**Re: 413 Harvard Dr. SE  
Grading & Drainage Plan  
Engineer's Stamp dated: 12-17-15 (K16D083)**

A PROPOSED  
GRADING AND DRAINAGE PLAN  
FOR RESIDENTIAL UNITS AT  
413 HARVARD DRIVE S.E.  
ALBUQUERQUE, NEW MEXICO  
OCTOBER, 2015

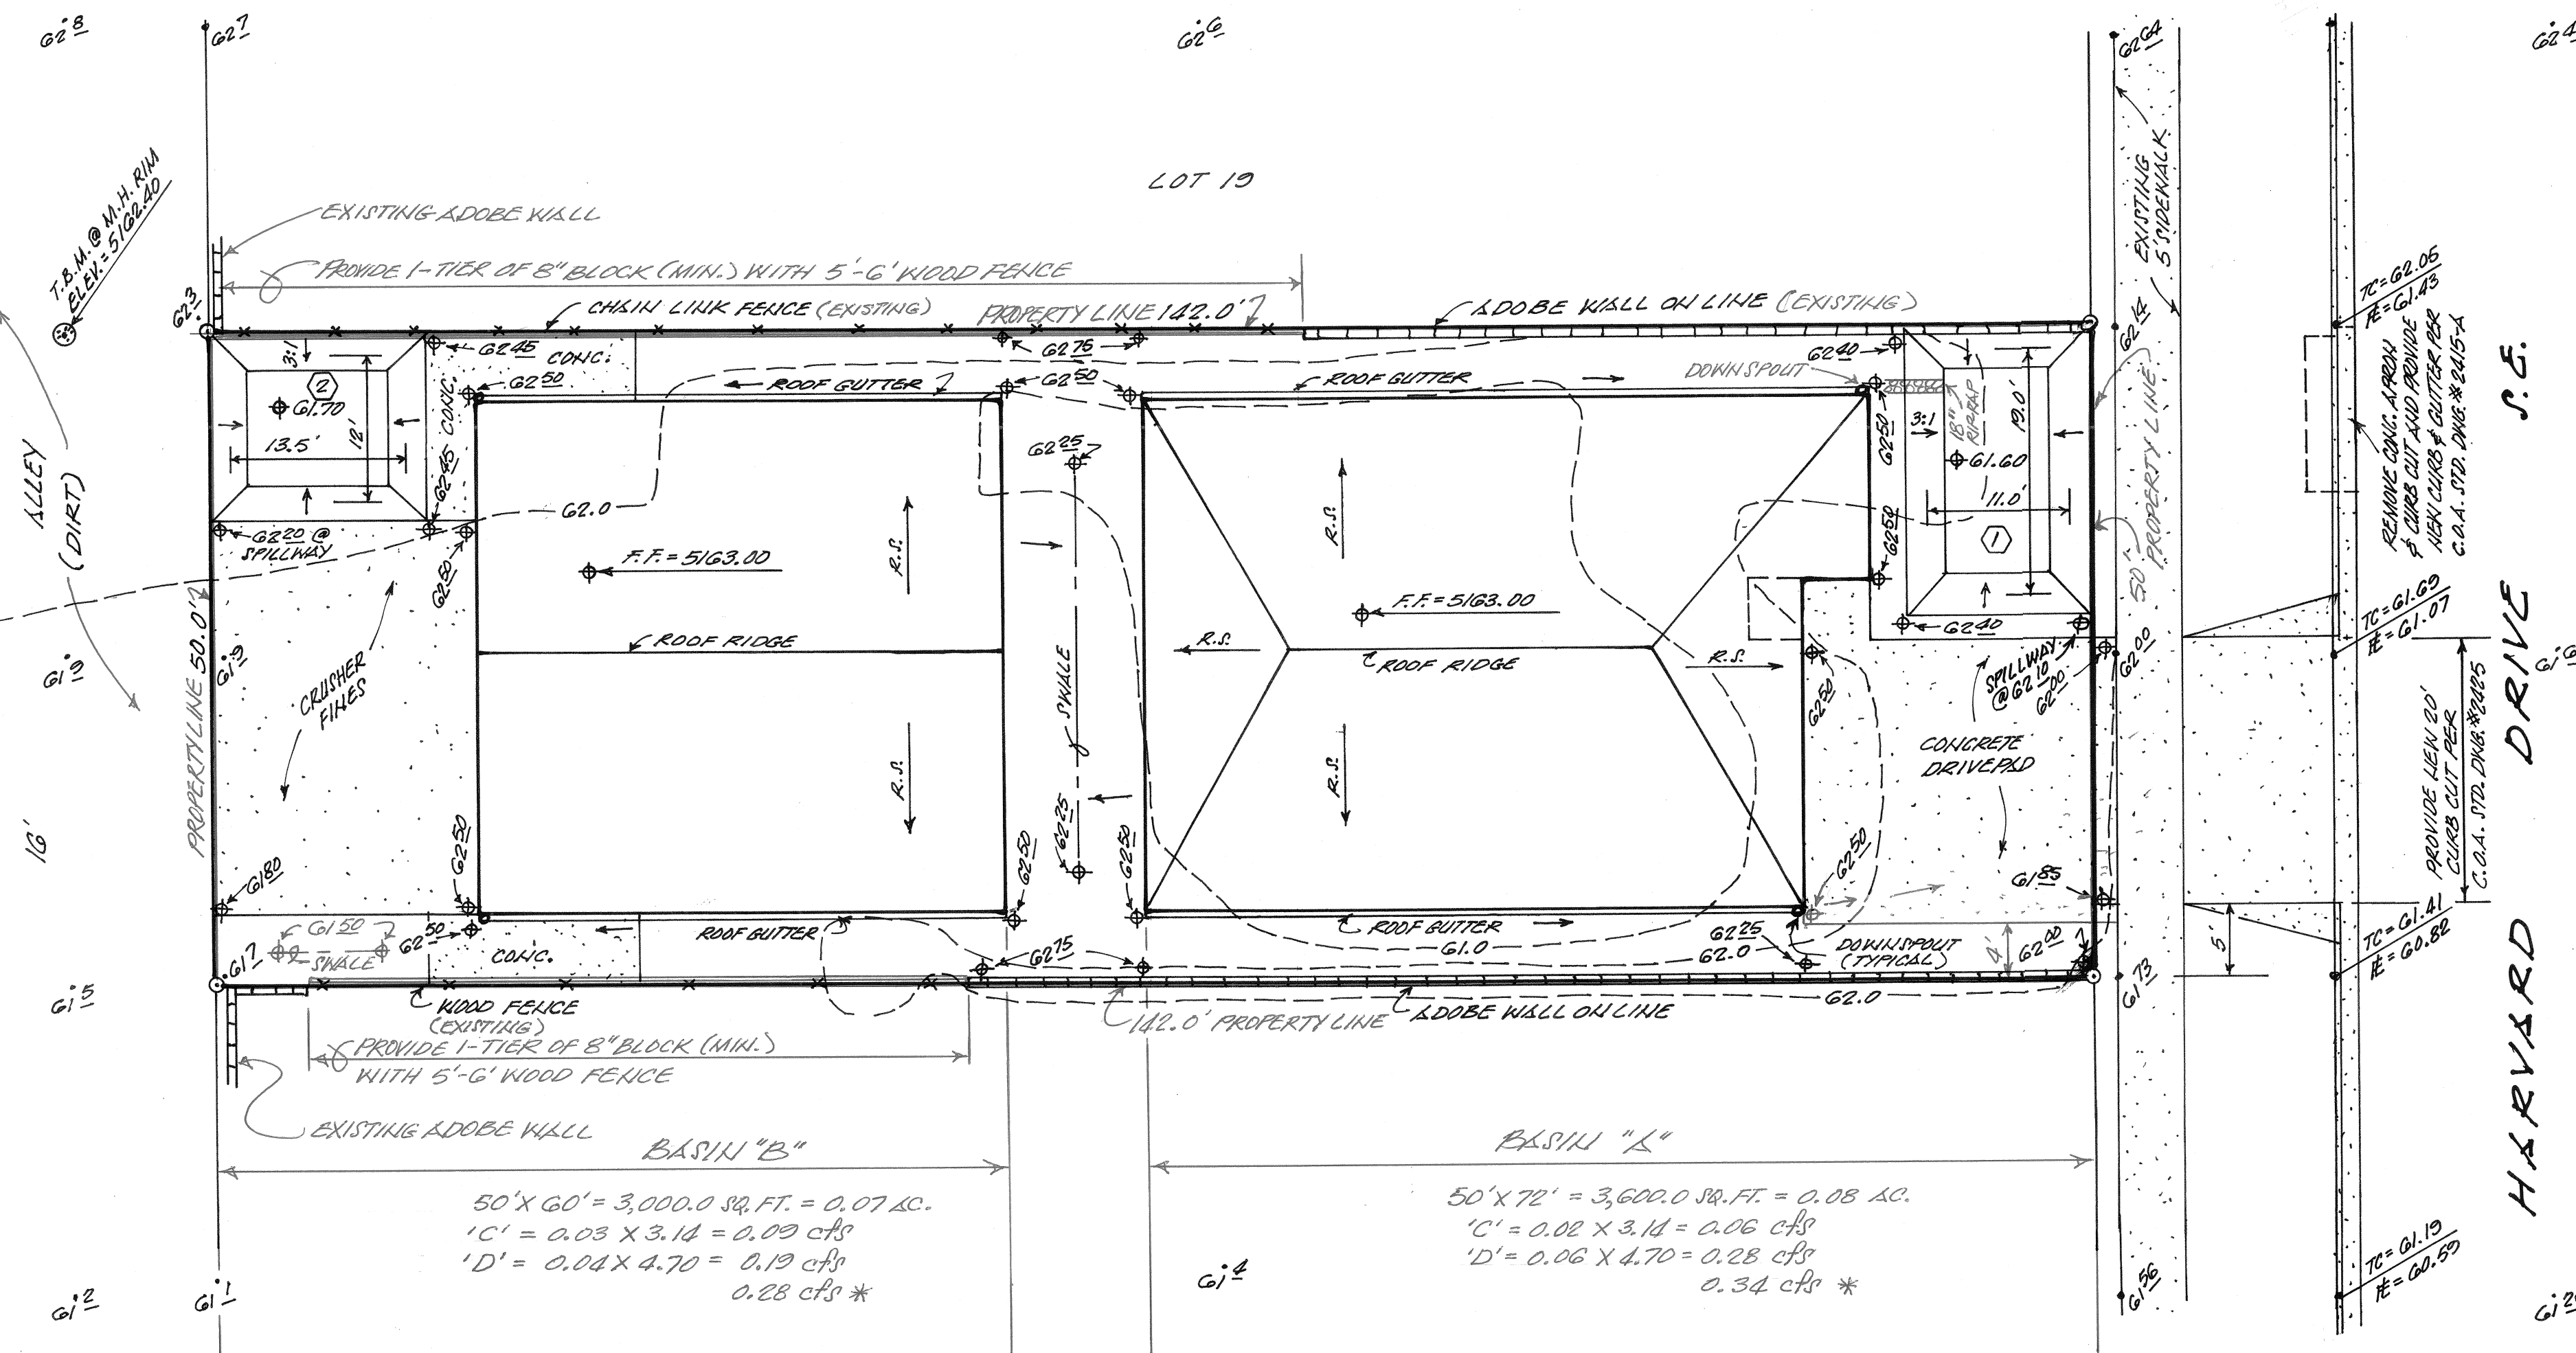
Based on the information provided in your submittal received 12/21/2015, this plan is approved for building Permit.

Please attach a copy of this approved plan, dated 10-26-15, to the construction sets in the permitting process prior to sign-off by Hydrology.

Prior to Certificate of Occupancy release, Engineer Certification per the DPM checklist will be required.
